May 13, 2026, 2026
Project #251527

Greg Kirton
Director of Planning
East Ferris Municipality
25 Taillefer Road
Corbeil, ON
P0H 1K0

Re: Clarification of Hydrogeological work completed for subdividing of Part of Lots 13 & 14, Concession 7 and Part of Lots 13 and 14, Concession 8; Township of East Ferris AND response to Public Comments received to date.

Figure 2 – Draft Plan of Subdivision

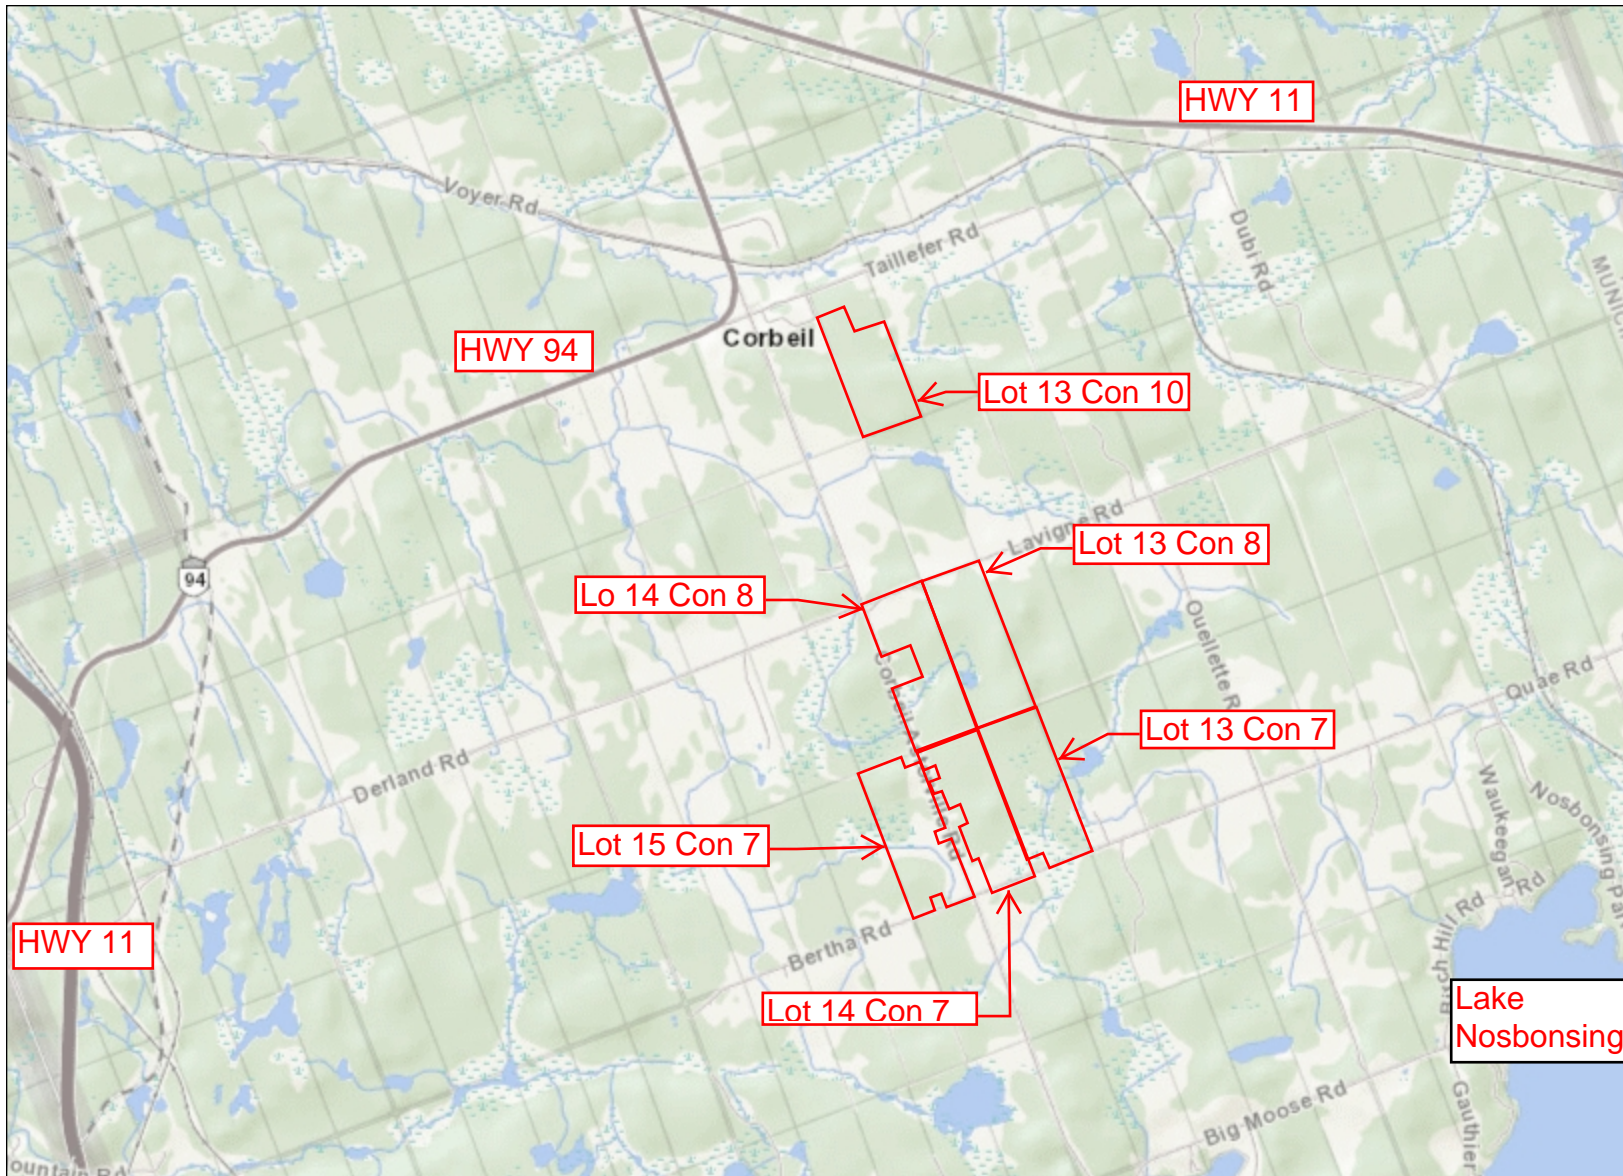
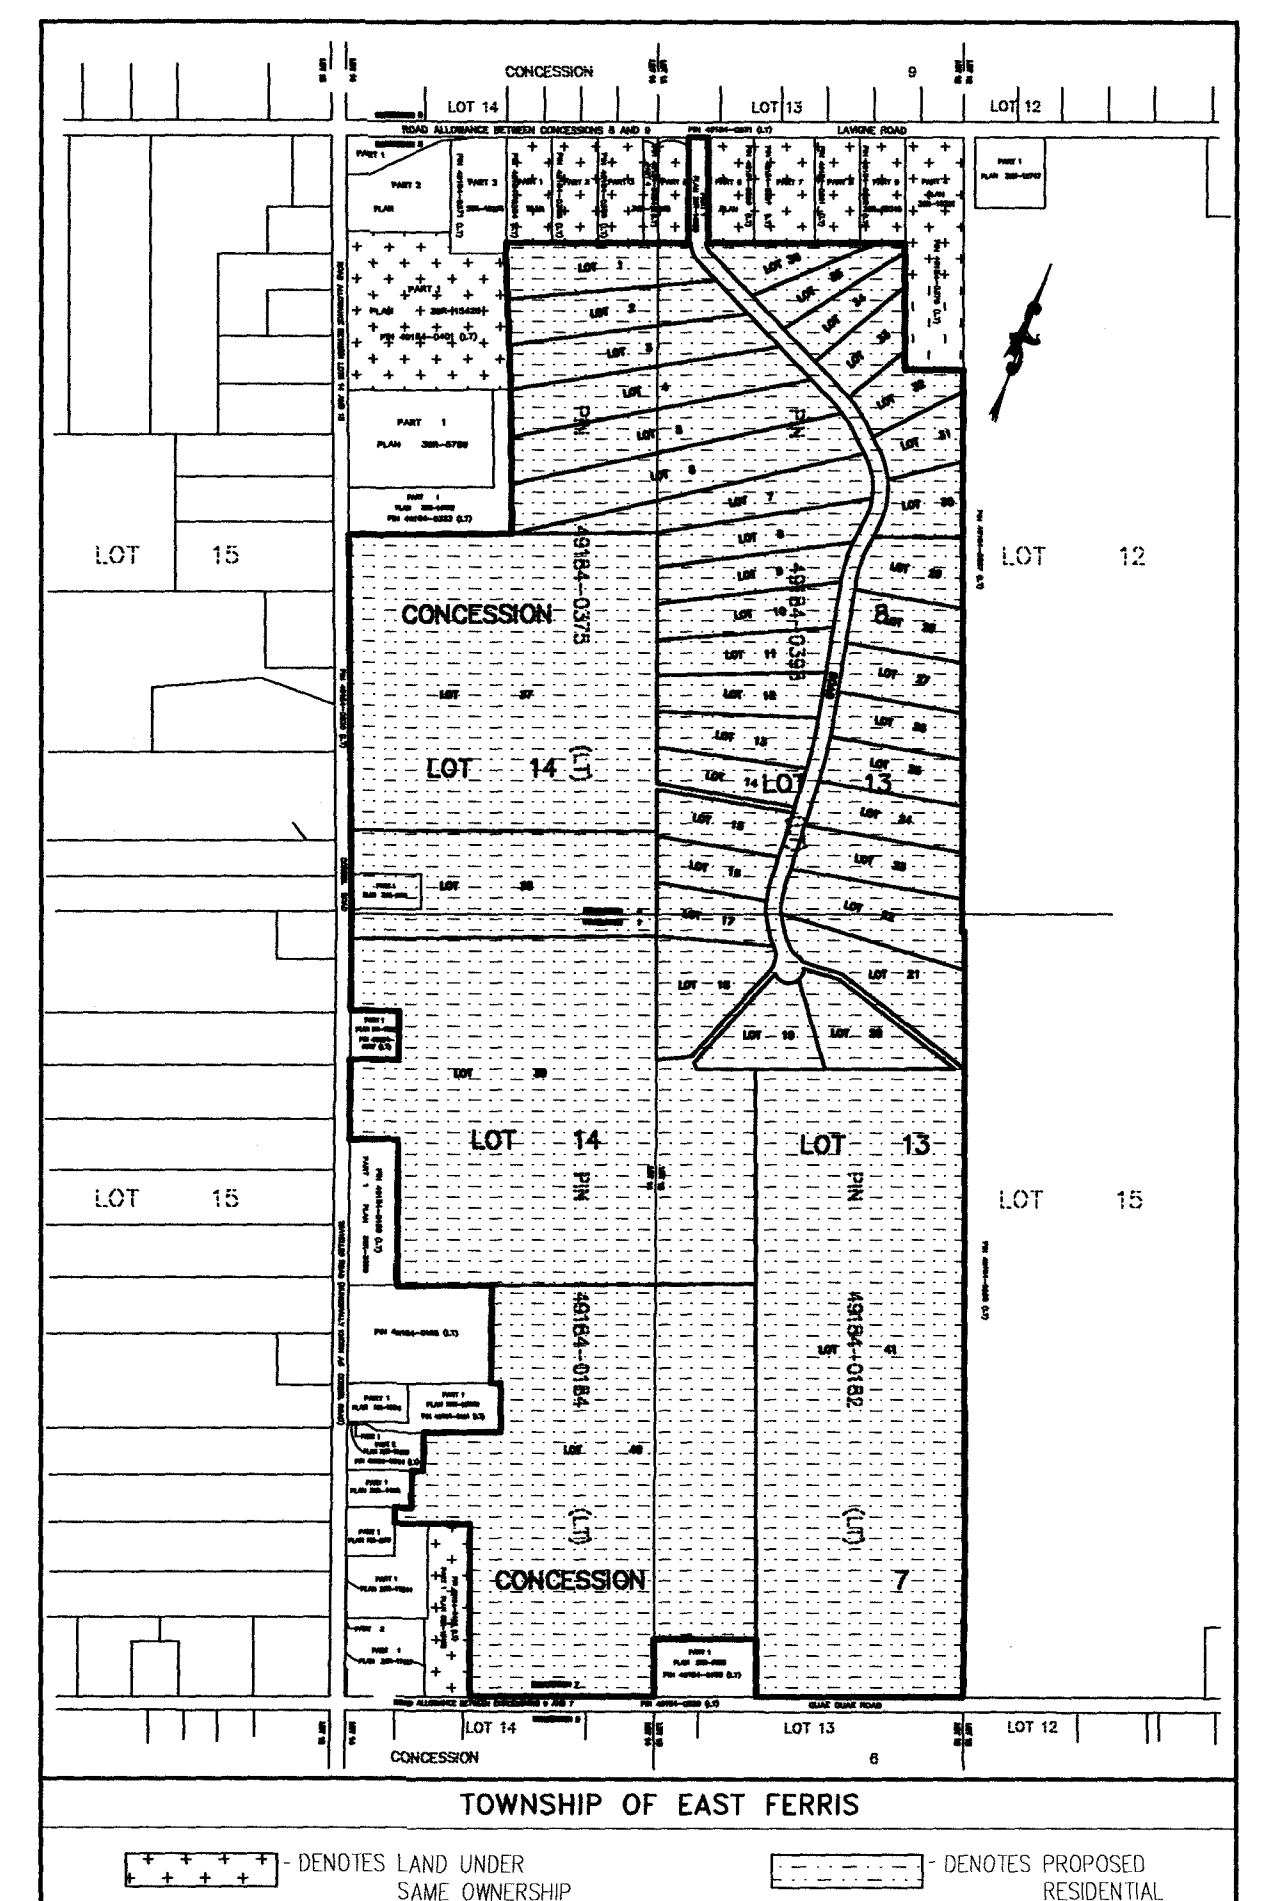
The lot layout for the subject properties now being proposed by the developer is shown on Figure 2 attached. The proposed development consists of dividing the subject properties into 41 estate lots. The total area of the subject properties is 134.12 ha while 2.55 ha will be allocated for road construction. This leaves 131.57 ha for estate lots. As shown on Figure 2, most of the lots (36) will be placed on the northeast portion of the property (yellow highlighted area) while the remaining 5 lots will be considerably larger as shown in the green highlighted area on Figure 2. The proposed lot sizes are summarized in the following table.

1. As shown in the table above, the minimum lot size is 0.8 ha which is larger than the minimum of 0.5 recommended to meet on-site sewage system requirements and consistent with the statement made in Section 1.1 of the hydrogeology report (proposed 0.8 ha and larger).

2. Due to the presence of wetlands or environmentally sensitive areas, the proponent has agreed to apply a much lower density development in the south part of the subject properties than originally considered when the hydrogeology report was completed in 2024. This results in an average lot size of 3.21 ha over the subject properties which is significantly higher than that envisioned at the time of completing the report.

3. The proposal now being put forth by the proponent will have less impact than projected in 2024 when completing the hydrogeological assessment.
4. Due to the overall lower lot density now being proposed, there will be even less risk of any noticeable groundwater impacts due to the preservation of natural areas and wetlands which will help with natural attenuation of on-site sewage system effluent and provide ample local sources of recharge for the bedrock aquifer.
